RECALL BULLETIN:
91222FRV

PRODUCT(S) AFFECTED:
Fiesta,
Terra

MODEL(S) AFFECTED:
34B,
manufactured
from August 28,
2009 through
November 5,
2009

SUBJECT:
Install new
Manufacturer
Federal
Certification
Tag and
Occupant and
Cargo Carrying
Capacity Tag

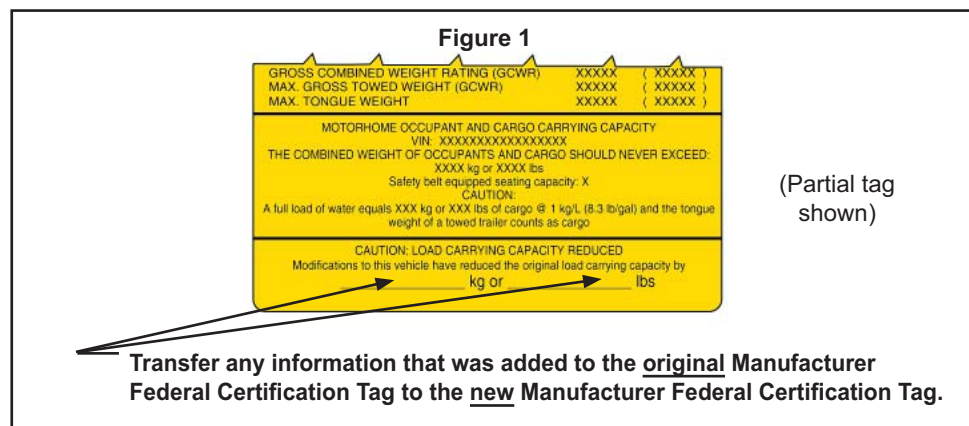
Fleetwood RV, Inc., has discovered that on the identified motor homes, the figures related to the fresh water tank capacity appearing on the Manufacturer Federal Certification Tag and the Occupant and Cargo Carrying Capacity Tag are incorrect. The correct water tank capacity is 50 gallons.

1. Locate the original Federal Certification Tag, adhered to the wall behind the driver's seat.
2. Record any additional weight information (if present) that was written on the original Manufacturer Federal Certification Tag due to the addition of options after the motor home was manufactured. (See Figure 1.) Transfer this information to the new Manufacturer Federal Certification Tag using a black, fine point, permanent marker.

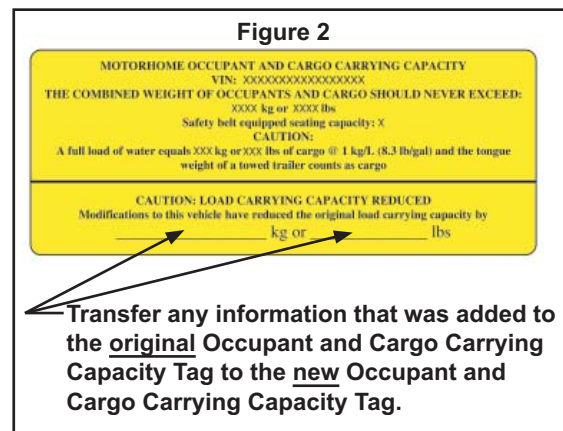
4. Locate the original Occupant and Cargo Carrying Capacity tag affixed to the inside of the entry door of the motor home. Record any additional weight information (if present) that was written on this tag due to the addition of options after the motor home was manufactured. (See Figure 2.) Transfer this information to the new Occupant and Cargo Carrying Capacity tag using a black, fine point, permanent marker. Then, remove and discard the original Occupant and Cargo Carrying Capacity tag.

5. Peel the adhesive backing from the new Occupant and Cargo Carrying Capacity Tag and carefully apply to the entry door in the same location as the original Tag. Use your fingers to smooth down newly-applied areas.
